## Proposal for amendments to the 04 series of amendments to UN Regulation No.41 (Noise of L3 category of vehicles)

The proposed amendments to UN Regulation No. 41, submitted by the expert from the International Motorcycle Manufacturers Association, are marked in bold for new or strike-through for deleted characters.

## Positioning of the microphones for the stationary noise test

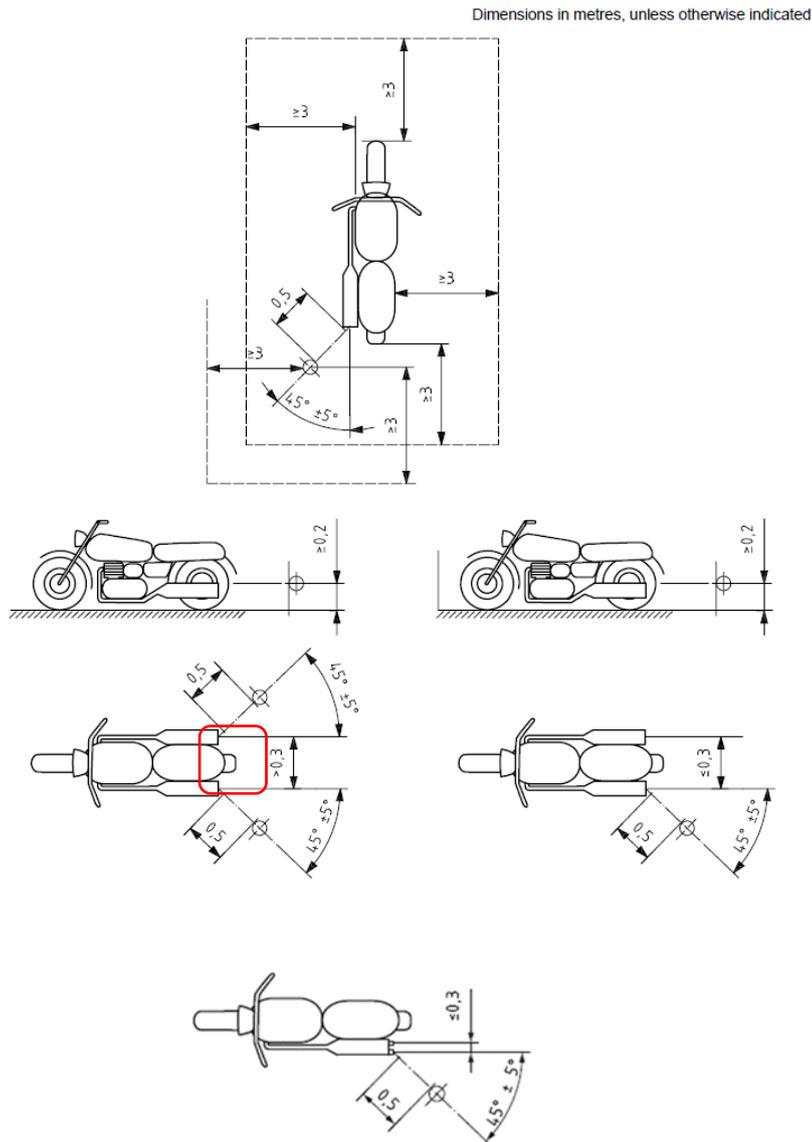
*Annex 3 – Appendix 2, amend to read:*

### Annex 3, Appendix 2:

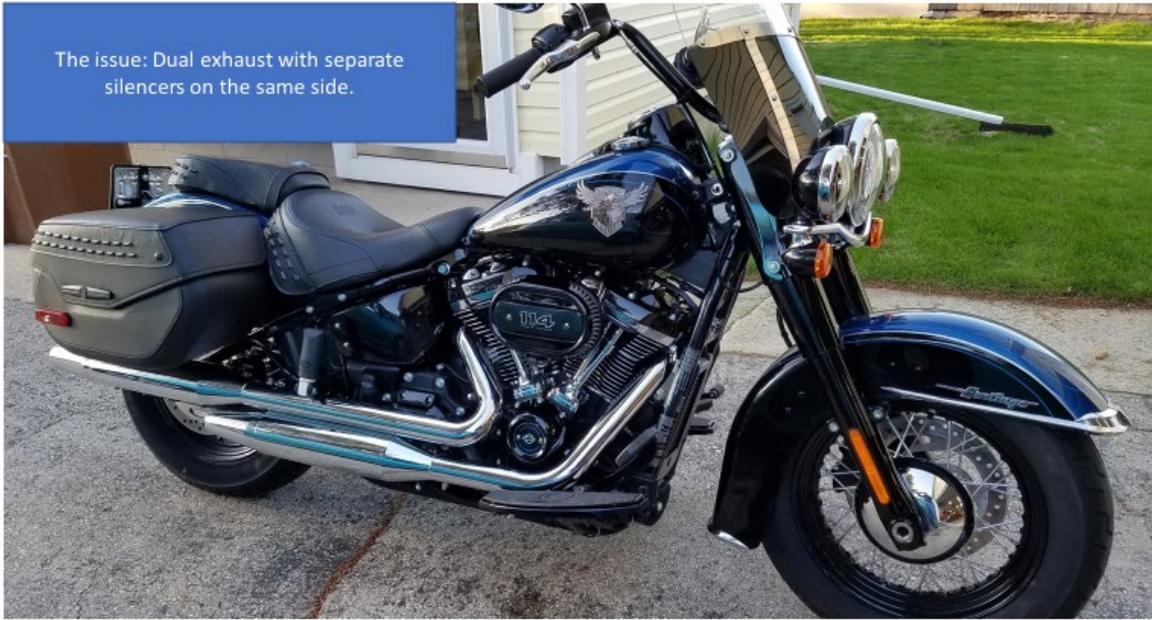
To correct an inconsistency between the text and the figure (ISO 5130 figure 1a) following changes should be incorporated:

Bottom left illustration (top view): distance between silencer outlets should be  $\geq 0.3$

Bottom right illustration (top view): distance between silencer outlets to be kept as  $\leq 0.3$

Softtail Dual Exhaust as Viewed from the Side

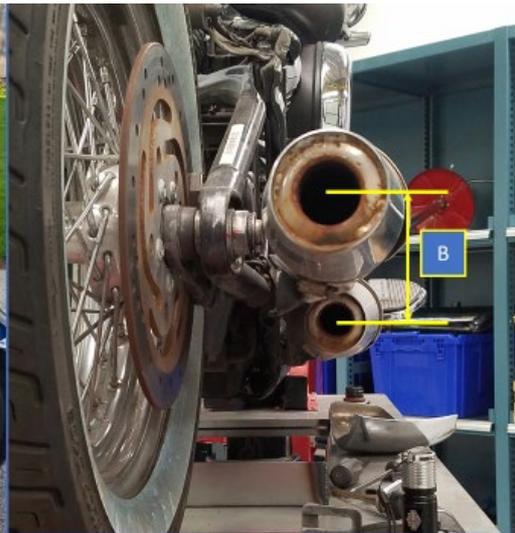
- Problem: to define how the measurement of 0.3 m is to be made:

The issue: Dual exhaust with separate silencers on the same side.

- Which viewpoint should for the 0.3 m threshold be considered?
  - IMMA recommends the measurement as viewed from the rear (shown in illustration B), as this is the flow axis of the exiting gases and sound.
-
